Transmitter Specifications and COM for 50GBASE-CR updated

Mike Dudek Cavium

- **This presentation is related to comments i-161, i-162, and i-163**

Proposed Changes. (These supercede those in my comments and has corrections since the ad-hoc)

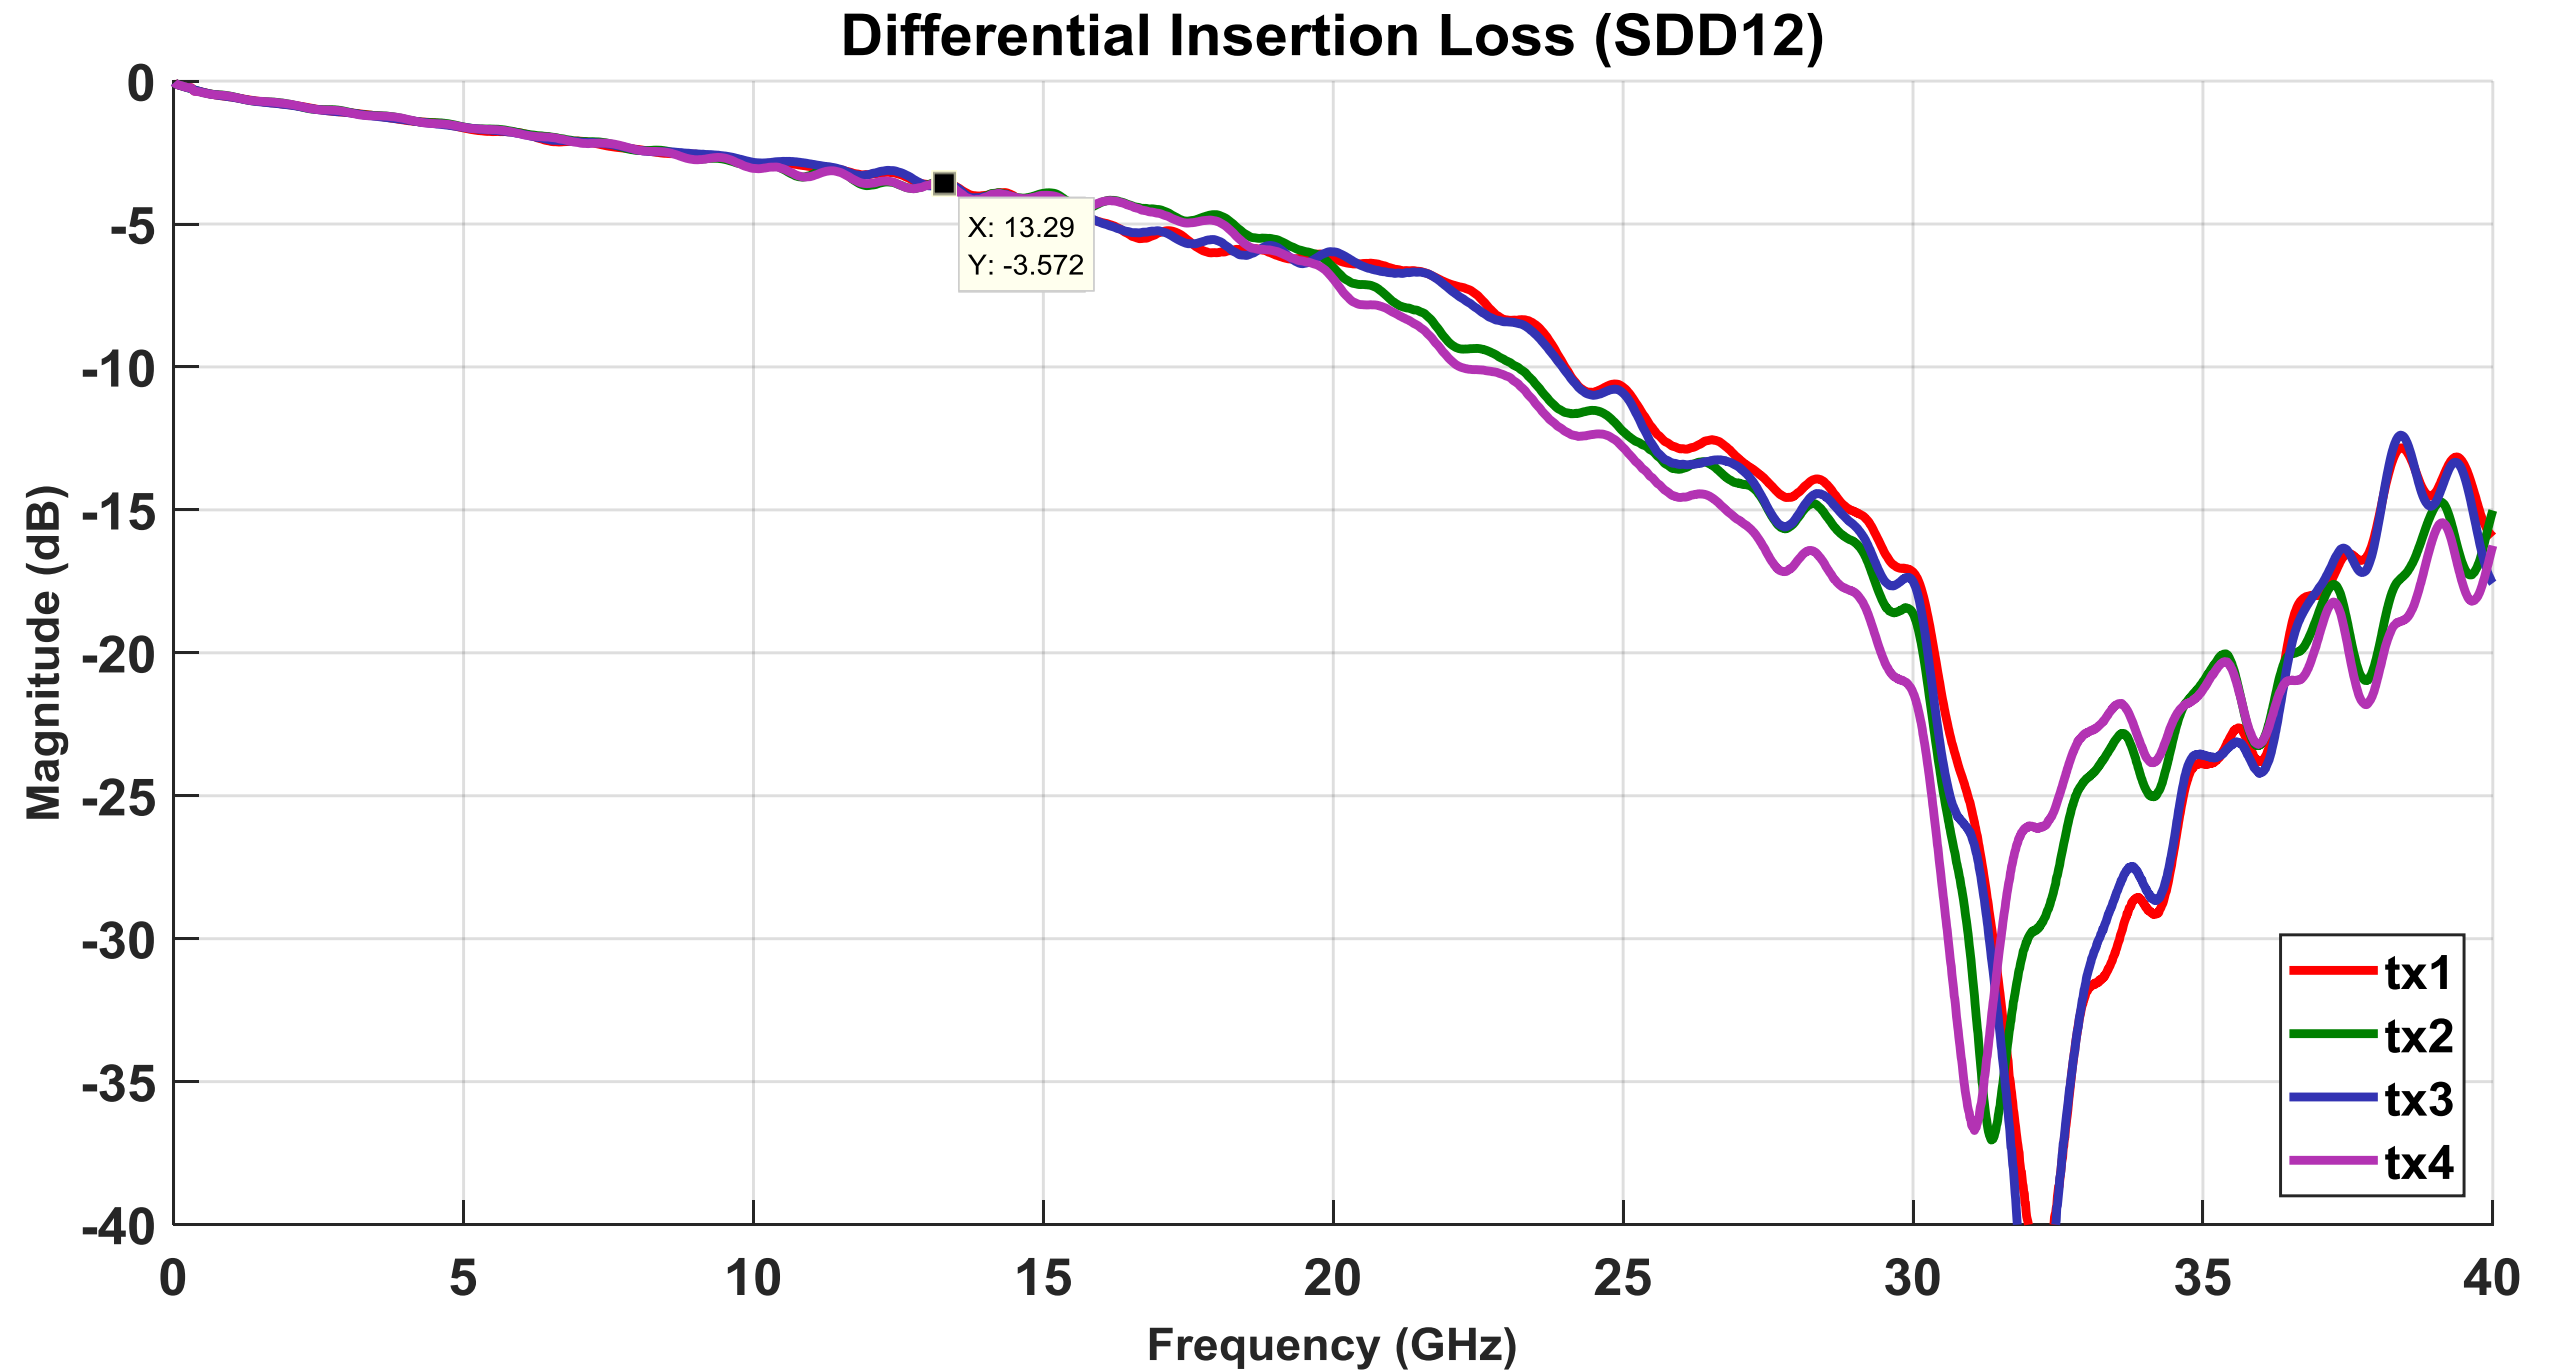
- **The draft 3.0 cable COM specification is more relaxed than that for the 25GBASE-CR-N and 25GBASE-CR-S cables implying that some tightening would be possible while maintaining the 3meter objective.**
- **Changing the parameters to match the 50GBASE-KR specification and the host PCB to 100 Ohm is desirable but doing just that would relax the cable specification further. Also it would require tighter specifications on the Tx than the existing worst case values making it difficult to make host Tx's.**
- **Note that there isn't any margin for Tx host noise (or impedance mismatch if the PCB is changed to 100 Ohm) as neither are included in the COM calculations.**
- **The next slide lists the proposed changes that will close the budget, correcting existing issues and making the desired changes.**

- **COM parameters**
 - **RD=50 Ohms (was 55)**
 - **Zc package = 95 Ohm (was 90 Ohm)**
 - **Av/Afe= 0.415 (was 0.45)**
 - **Ane=0.604 (was 0.63)**
 - **Add an exception that Zc for the PCB = 100 Ohm (on page 236 line 39 change “parameter values given in Table 92-12” to “parameter values given in Table 92-12 except that Zc=100 Ohm” (was 109.8 Ohm)**
- **COM pass/fail criterion 3.3dB for Cable test (was 3.0dB), 3.0dB for interference calibration (no change).**
- **TX specifications**
 - **Add a sentence to 136.9.3.1.2 stating that Nv=13. (was effectively infinite)**
 - **Vf(min) = 0.354V (was 0.34V)**
 - **SNRisi=31.2dB (was 36.8dB)**
 - **SNDR=32dB (was 33.3dB)**
